Agency: U.S. Nuclear Regulatory Commission
Advisory Committee On Reactor Safeguards

Title: 336th ACRS Meeting

DATE: Thursday, October 4, 1990 PAGES: 1 - 113

10 Proposed license renewal standard review plan and
11 associated Regulatory Guide;

FIGURE 1A
Integrated Plant Assessment -- Identification of Important-To-License-Renewal SSCs and SCs Requiring Evaluation of Age-Related Degradation

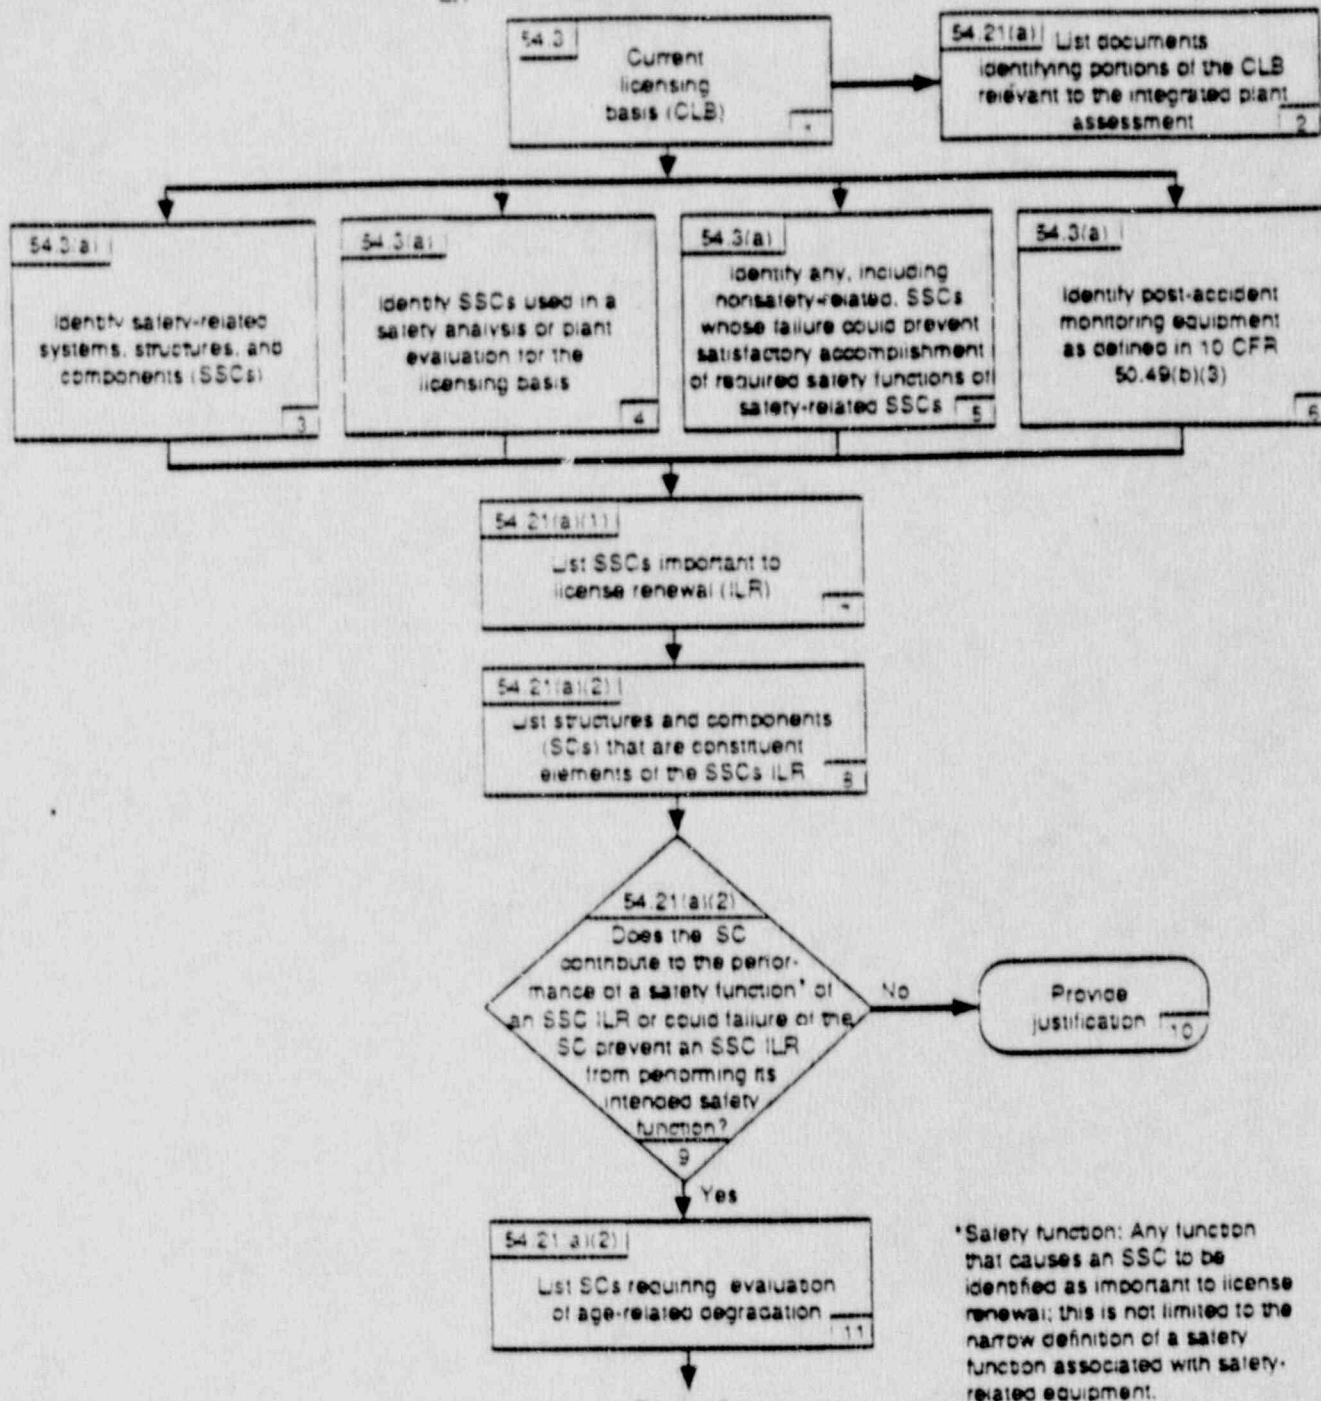
20 MR. VORA: That's correct. But this is how it
21 starts out, the whole formal process. We start with the
22 current licensing basis and then include those components
23 which are defined in the rule, those four blocks, and then
24 narrow it down to the selection of components and
25 structures.

19 I mean, I guess my concern is that this, the
20 activity in Block 5 is going to sort of permit -- I don't
21 want to be too pejorative about it -- but sort of unfettered
22 expansion of regulatory activity in the parts of the plant
23 that haven't been subjected to regulatory activity before,
24 granted, only in terms of aging management, but it will be
25 up to the reviewer of a particular license renewal

FIGURE 1B
Integrated Plant Assessment -- Evaluation of Age-Related Degradation

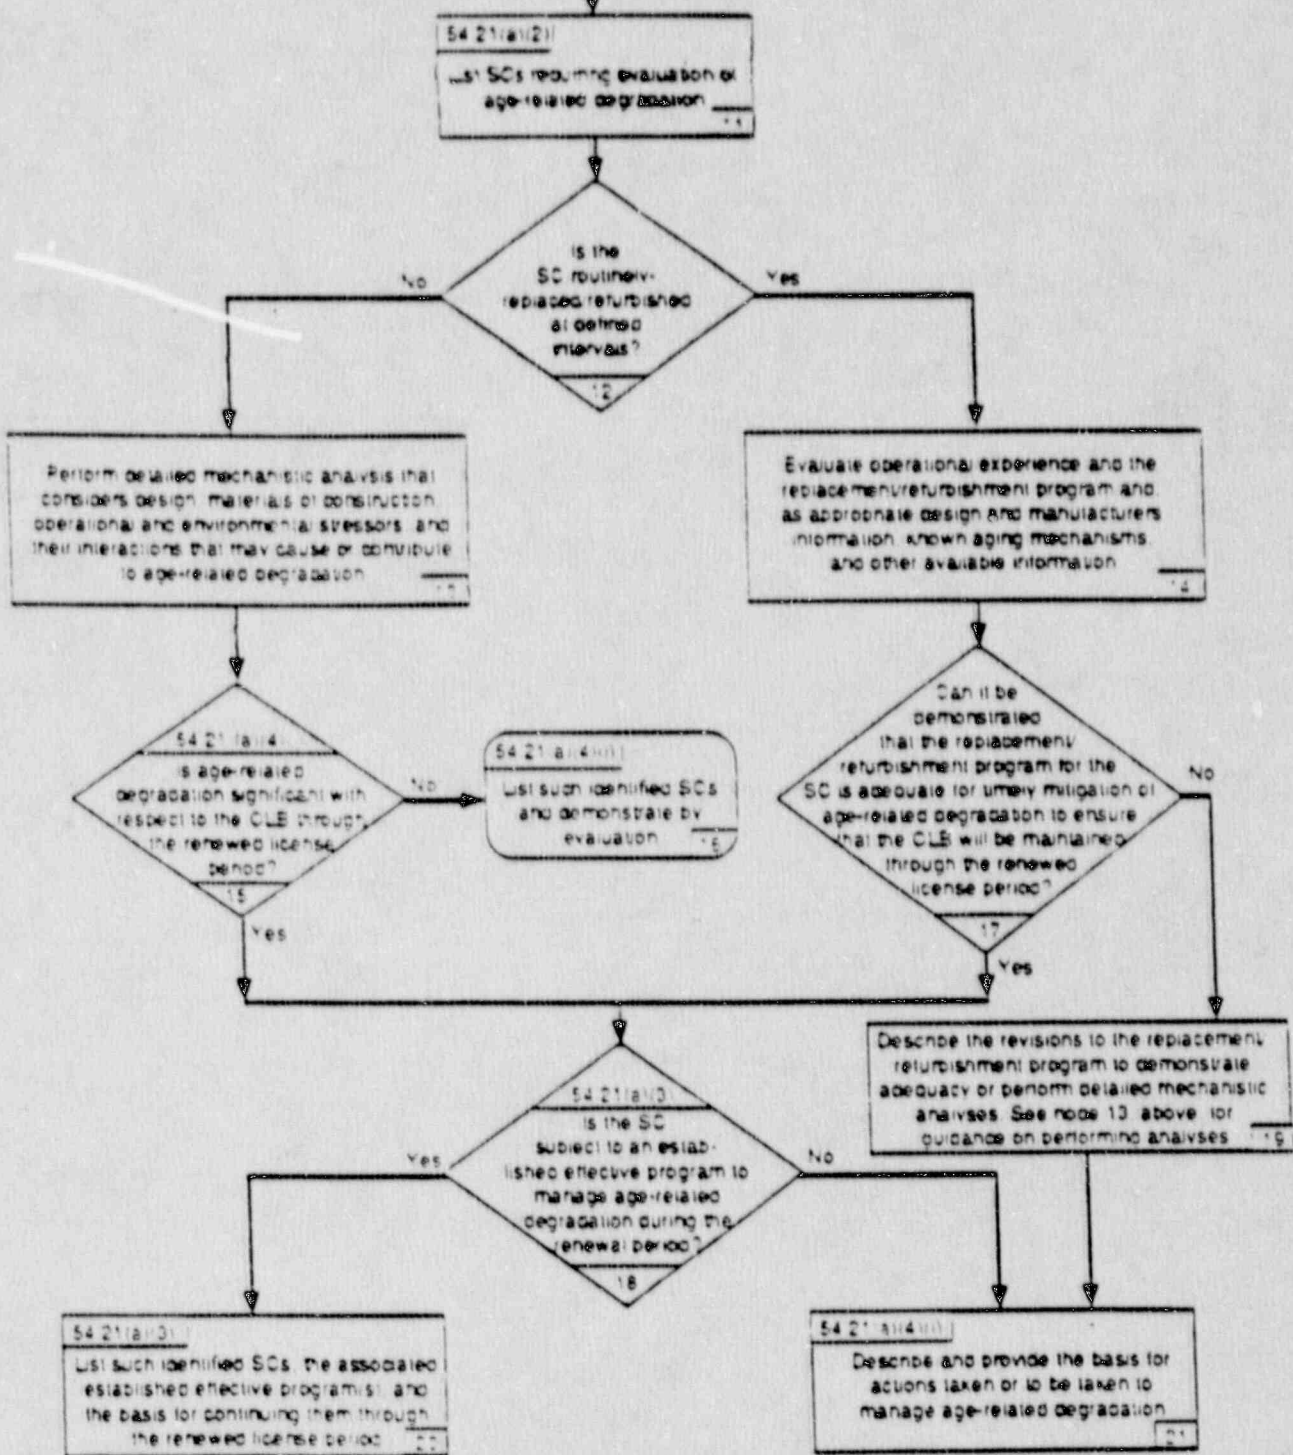
20 The flow chart in Figure 1B of the handout
21 provides guidelines for the evaluation of age-related
22 degradation and part of integrated plant assessment. Metal
23 has been provided for evaluation of structures and
24 components which are routinely replaced or refurbished at
25 defined intervals. These are normally identified as the
